Handling and Servicing Safety-Related Product Bulletin

**Genesys™ 3U 10kW/15kW products with rated output voltage 600V or below.
Genesys™ 2U 3.3kW/5kW products with input voltage 400VAC or 480VAC
All models of GENESYS+™ 5KW**

Genesys™ 2U 3.3kW and 5kW 3-phase 400V and 480V

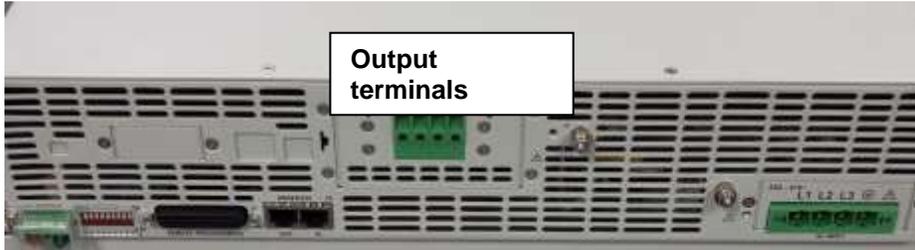
Connect other end to negative output terminal and hold for 2 seconds.

Connect other end to positive output terminal and hold for 2 seconds.
